Technical Service Information

AUDI AND VOLKSWAGEN 01M MULTIPLE SOLENOID CIRCUIT CODES

Figure 1

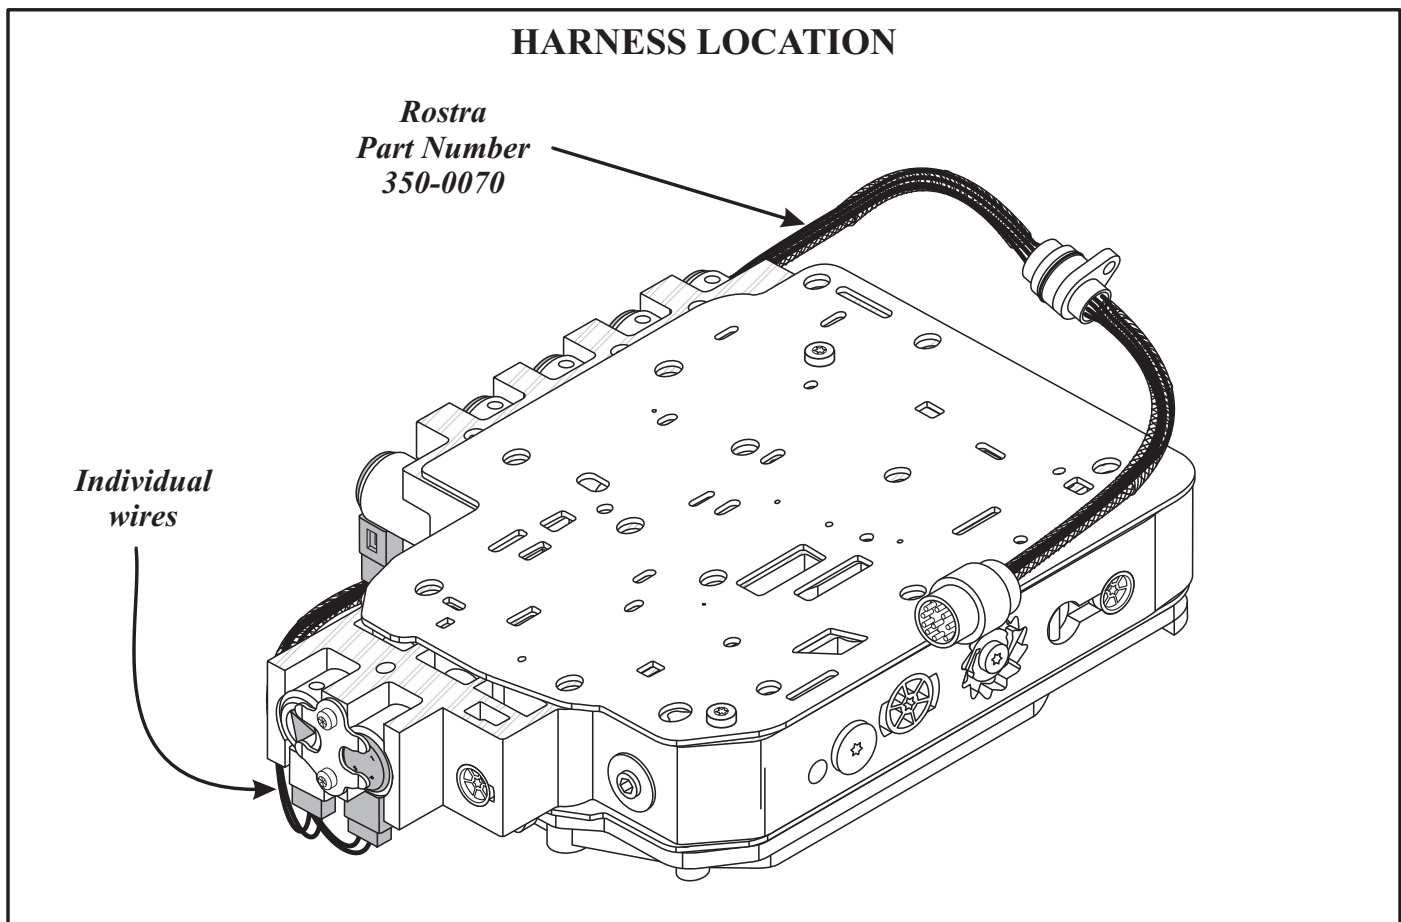
CAUSE: The cause may be, a faulty or broken "Ribbon strip." This ribbon strip connects all of the solenoids to the transaxle harness connector and is known to have brittle connectors.

CORRECTION: Refer to Figure 2 to check all of the ohm values to all of the solenoids. Replace the Ribbon strip as necessary. The Ribbon strip can be replaced with a new internal harness available from Rostra that has separate wires rather than a molded harness. See Figure 1.

INTERNAL WIRE HARNESS (*Rostra part number*).....350-0070
